BCA COMPLIANCE REPORT

PROJECT NUMBER: 220223

PROJECT DETAILS: Suburb Thredbo Lot 768 DP1119757

CLIENT: Le Hunte Properties

Project Number	12656
Drawing Name	Elevations - Sheet 1
Scale	1:200 @ A1
Date	June 2022
Drawing Number	DA300
Revision	E

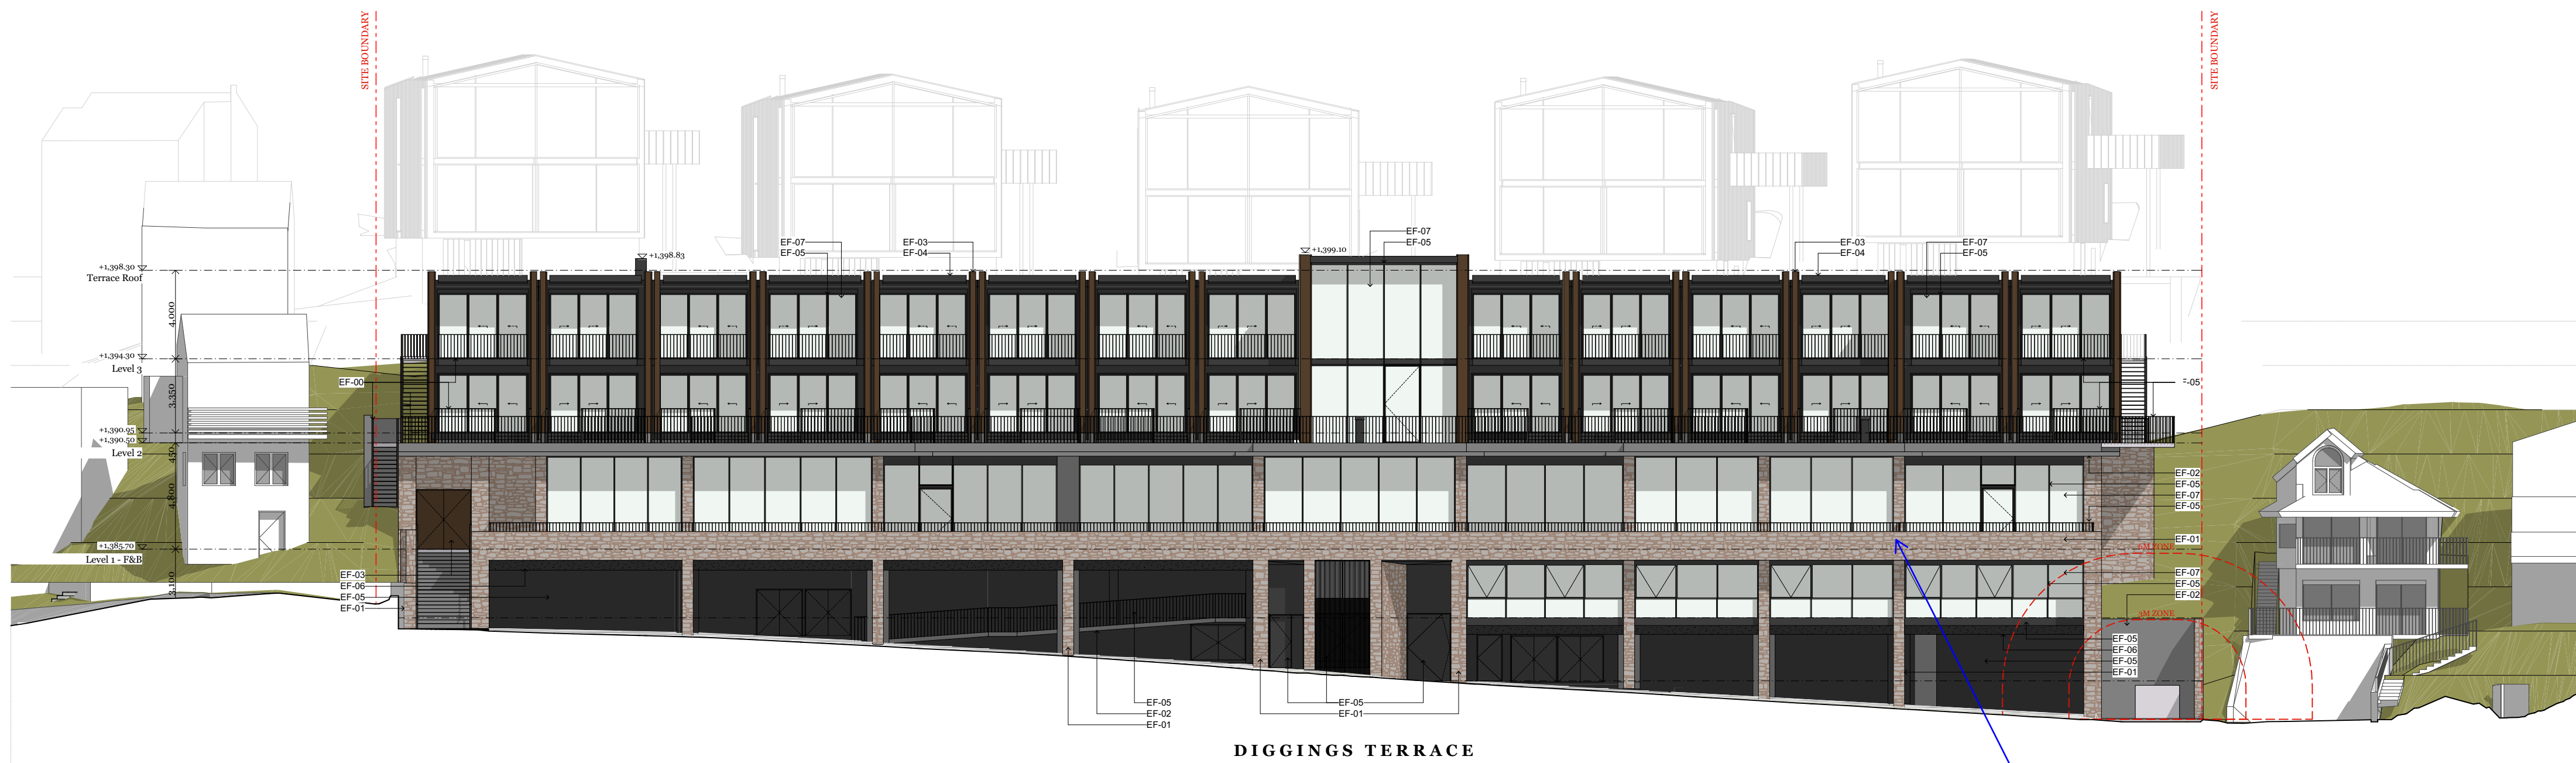
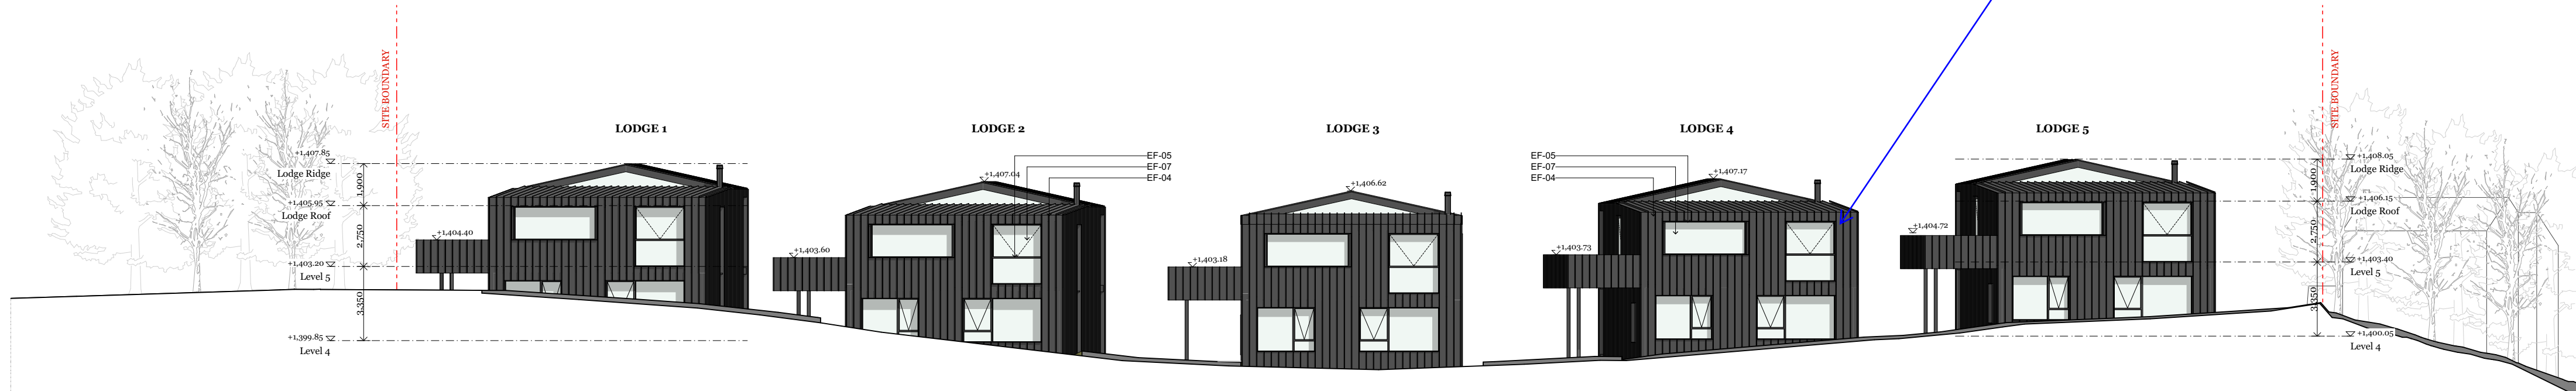
Facade consultant to review all external wall types and construction methods with regards to combustibility and weatherproofing requirements.

Project Number	12656
Drawing Name	Sections - Sheet 1
Scale	1:200 @ A1
Date	June 2022
Drawing Number	DA303
Revision	H

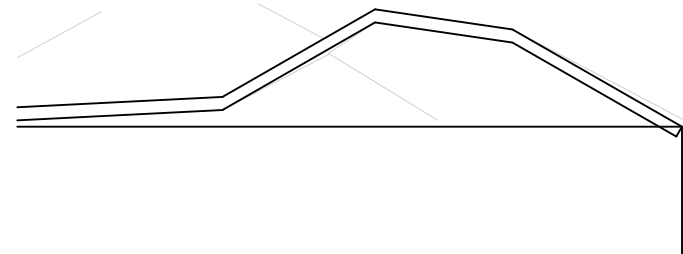
Ensure min 2200mm clearance is achieved throughout all car park spaces particularly below the mechanical ductwork and beams.

Project Number
Drawing Name
Scale
Date
Drawing Number
Revision
12656
Sections - Sheet 3
1:200 @ A1
June 2022
DA305
H

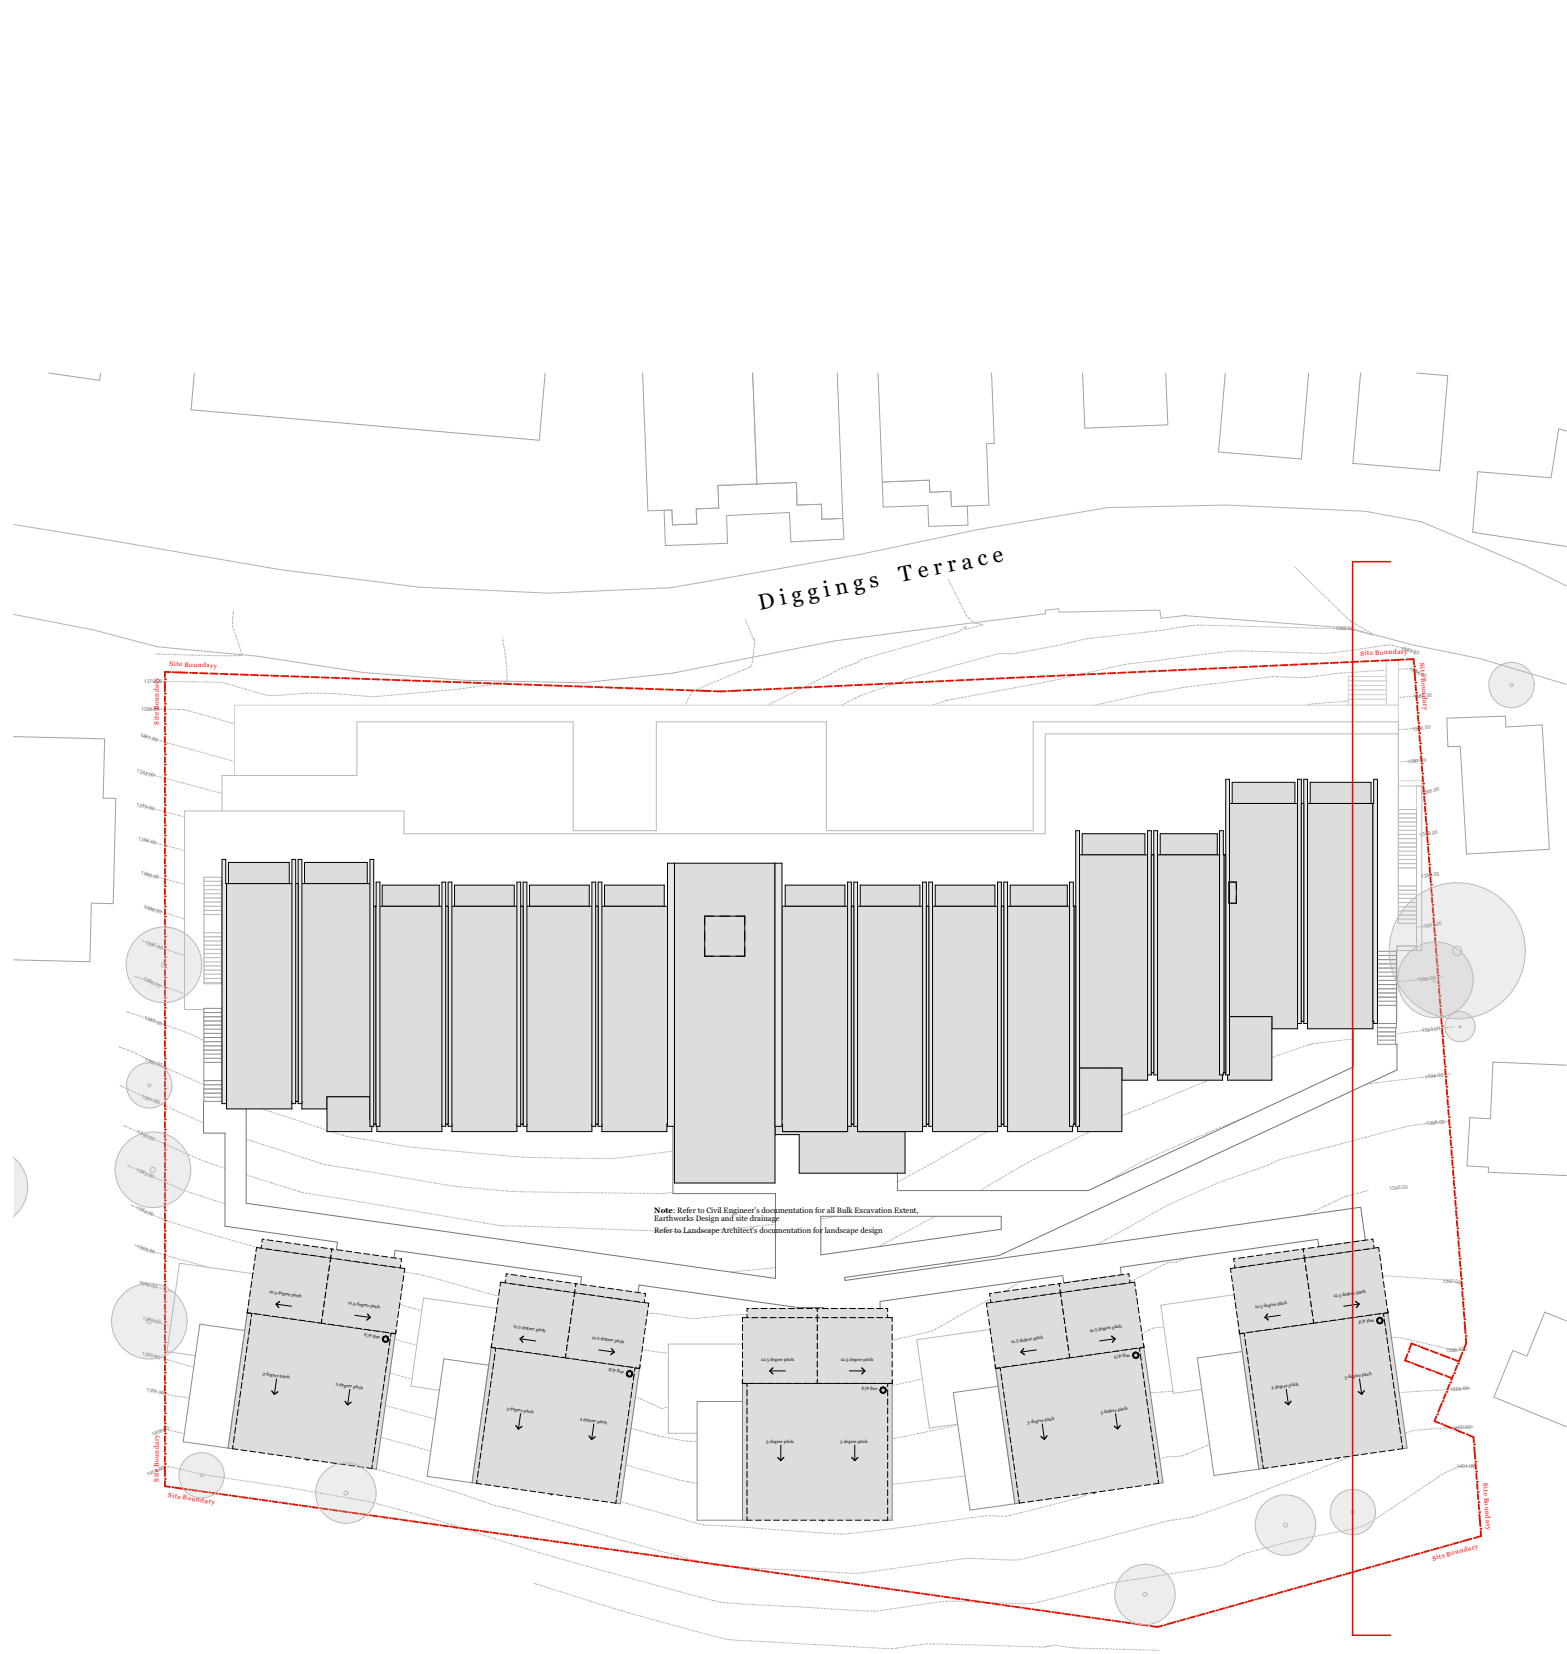
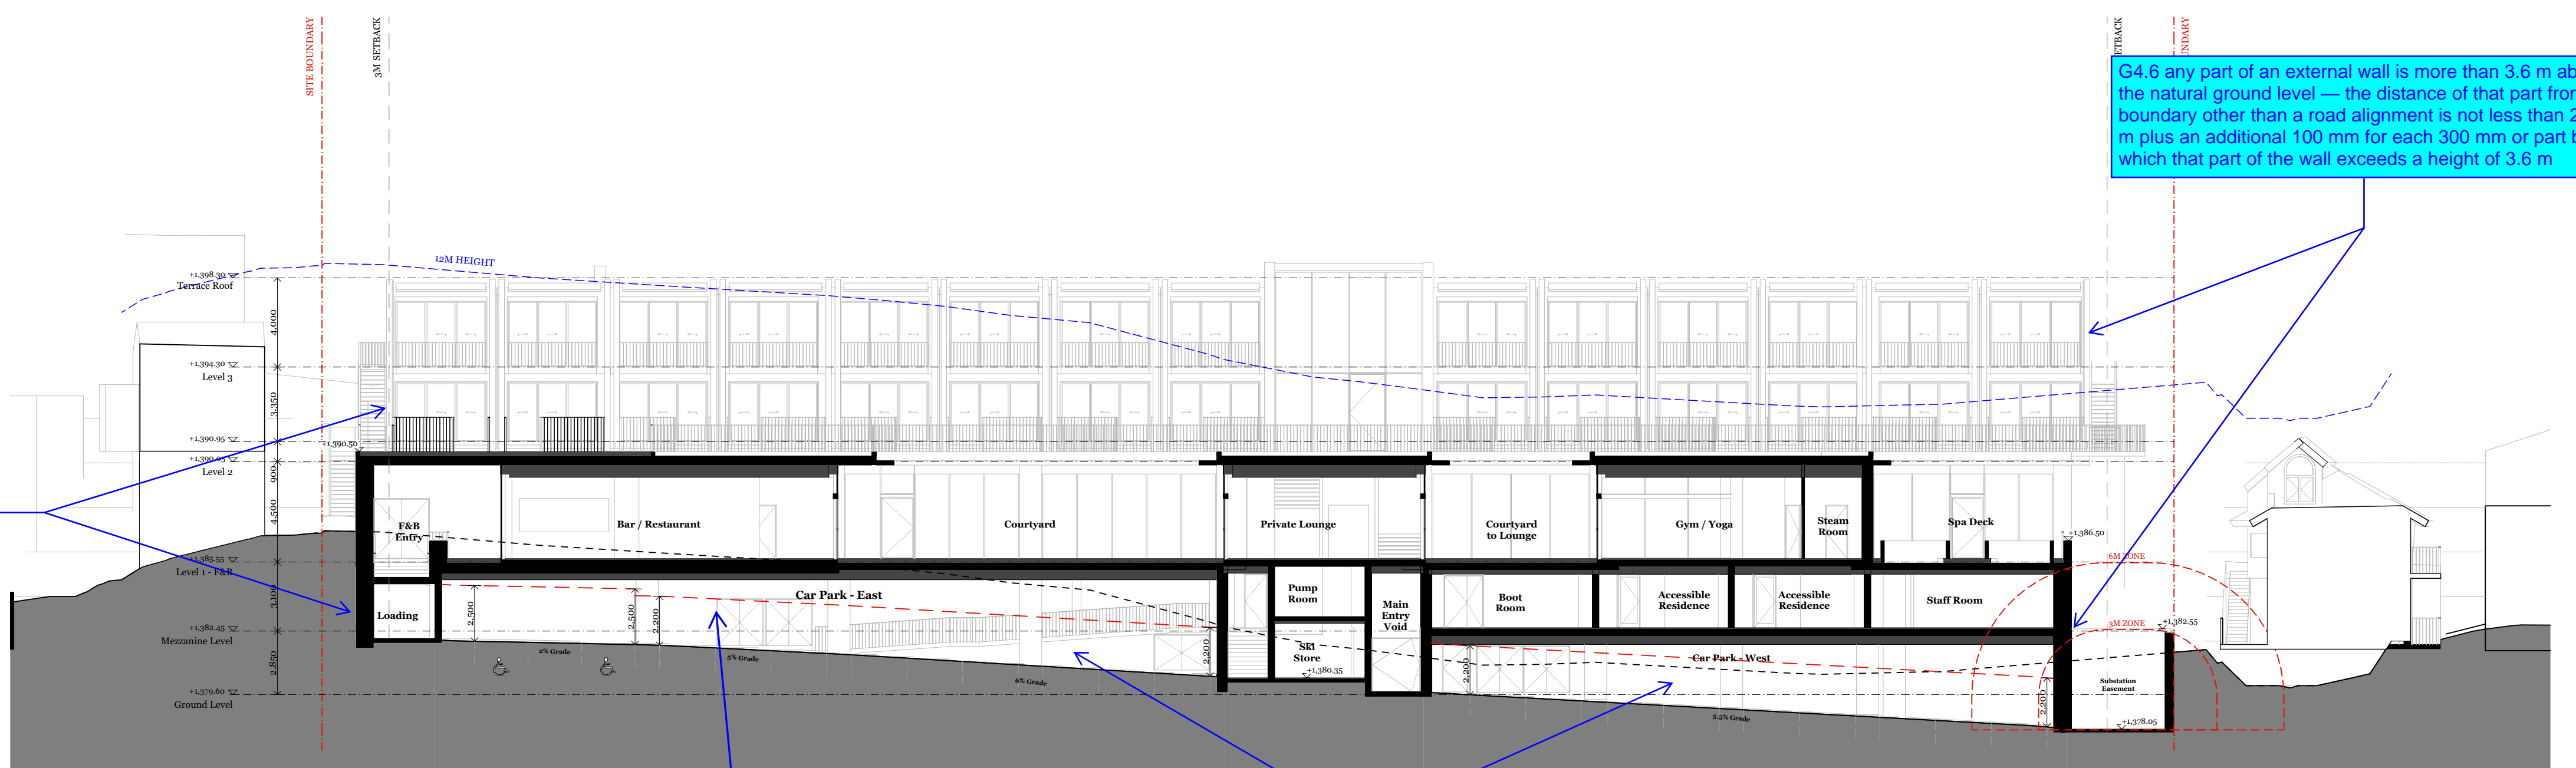
Ensure minimum 2500mm clearance is provided above all accessible car park spaces. Sprinkler pipes and lights to be reviewed by service consultant and architects.

Ensure min 2200mm clearance is achieved throughout all car park spaces particularly below the mechanical ductwork and beams.
